***The CITADEL
Summerall Chapel Stained Glass Restoration 2025
Project H09-N186-ML***

***ADDENDUM #2
To Bid Documents dated September 17, 2024
October 8, 2024***

***The CITADEL
Summerall Chapel Stained Glass Restoration 2025
Project H09-N186-ML***

***ADDENDUM #1
To Bid Documents dated September 17, 2024
October 3, 2024***

SK-1
 SRT

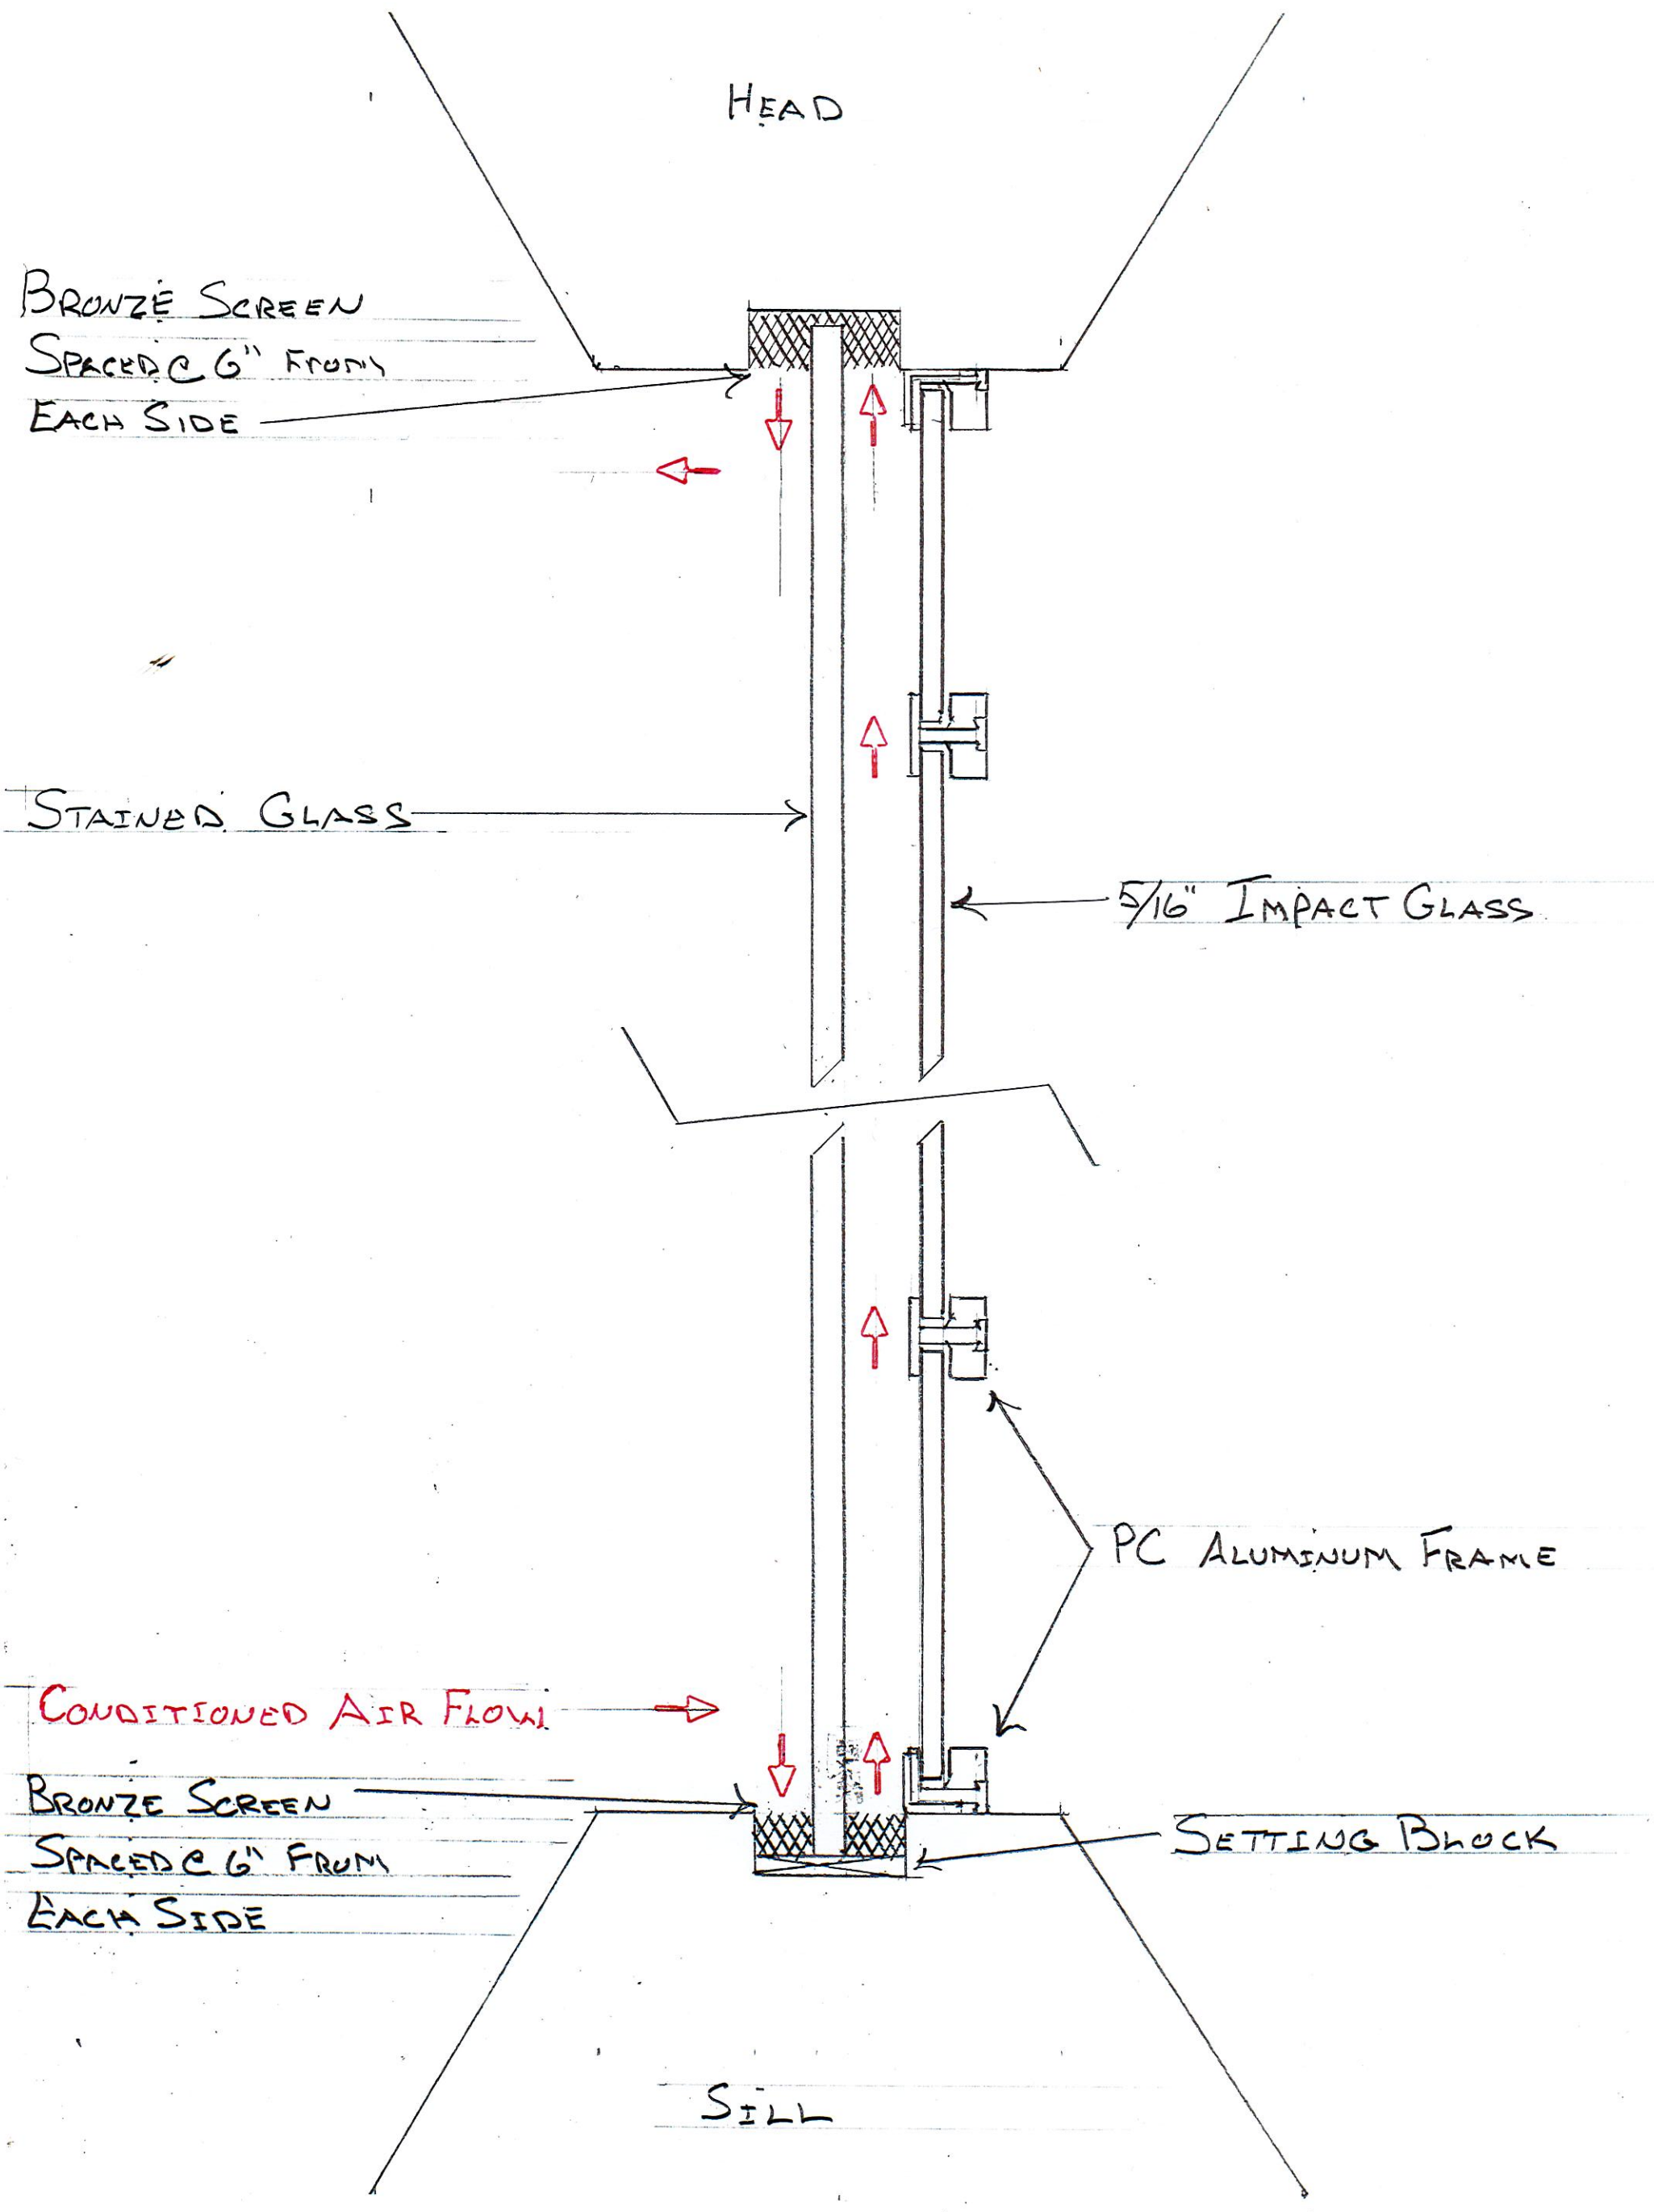
2. QUESTION – Venting the windows to the interior would allow conditioned air between the two panels and eliminate condensation between the stained glass and the protective covering. In the summer months, if condensation did occur from the extreme hot and humid weather, the condensation would accumulate on the exterior of the protective covering and not between the two surfaces. This would also be less intrusive than venting the extrusions on the exterior. Can this be used? (please see attached).

ANSWER – The proposed interior ventilation system does not appear to address the anticipated condensation on the inside face of the protective covering, or provide a means for internal drainage through weep holes or channels, in the predominantly hot and humid climate of Charleston. The proposed system is not approved for use.
